March 15, 2021
412 Blvd of the Allies Office Build-Out
IFB #600-01-21

ADDENDUM NO.11

RE: 412 Boulevard of the Allies – 1st, 5th, 6th, 7th Floors: Bidding Addendum #11

4 ACOUSTIC PANEL @ LVL 01 WALL
1 1/2" = 1'-0"

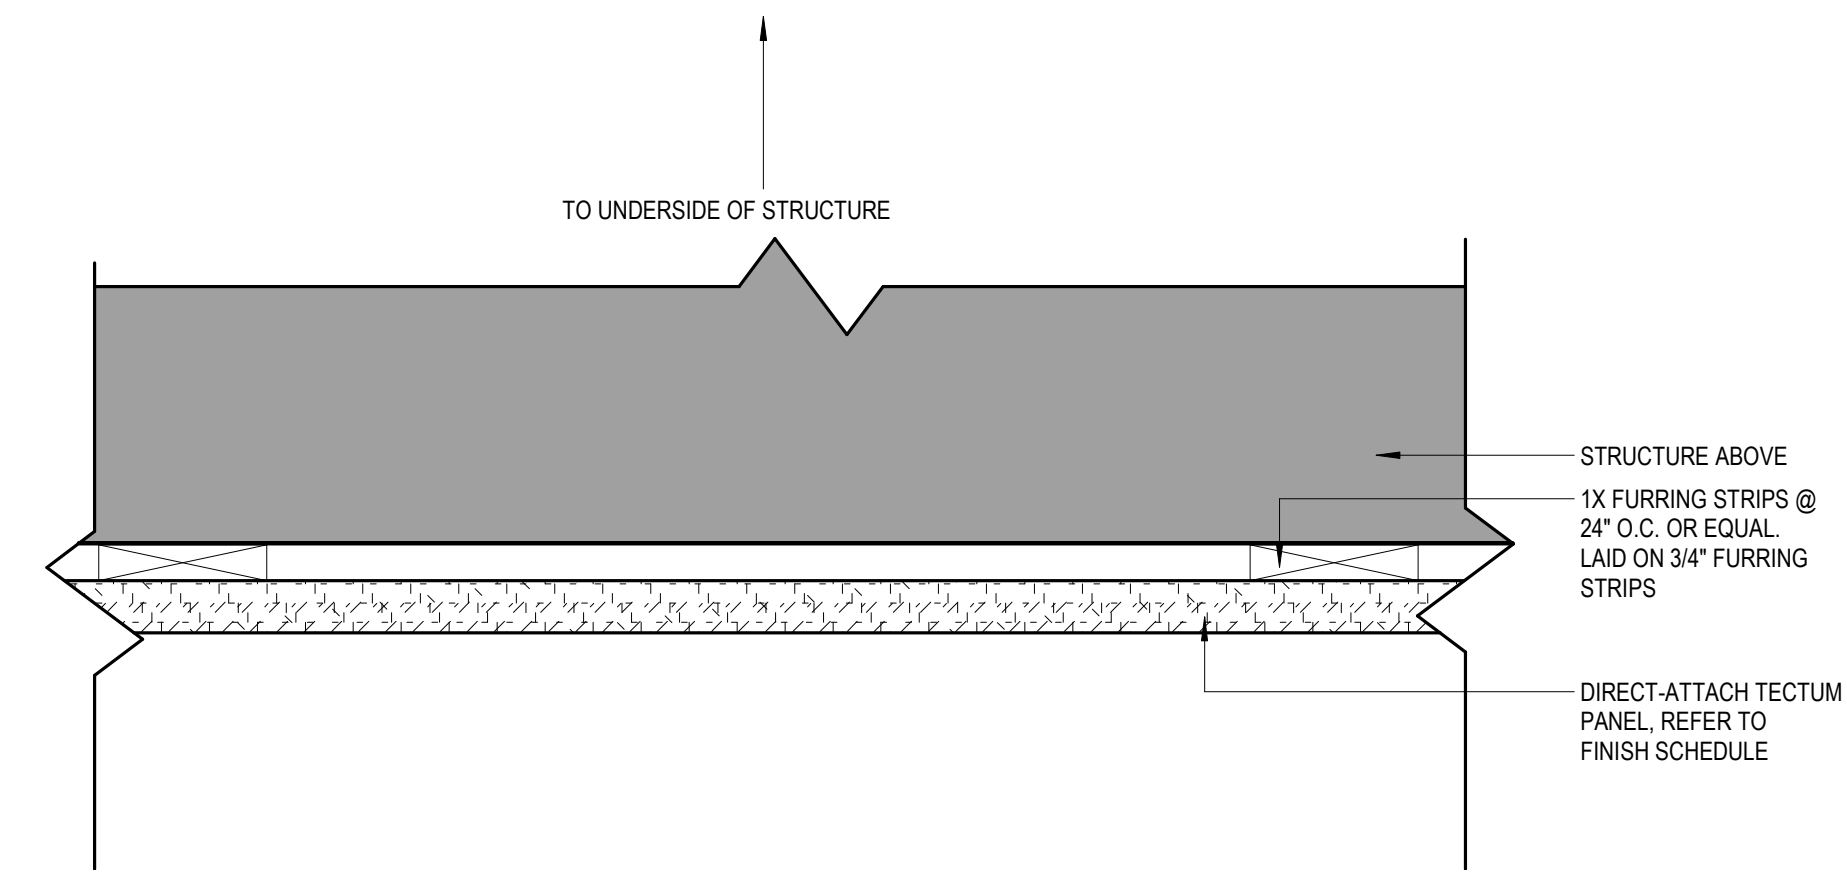
1. Sheet A560R – Ceiling Details
 - Updated ceiling detail to include CSI Wall Panel install as an approved substitution.
2. Sheet A641R – Interior Finish Schedules
 - Updated finish schedule to include CSI Wall Panels as an approved substitution.

Item 13: In regard to Addendum #7, Item #13, substitution request by CSI Wall Panels for the Soundcore® Plus Panels in lieu of the FeltWorks® Panel by Armstrong is hereby approved. More information including revised applicable drawings are provided in **Attachment 1** to this addendum.
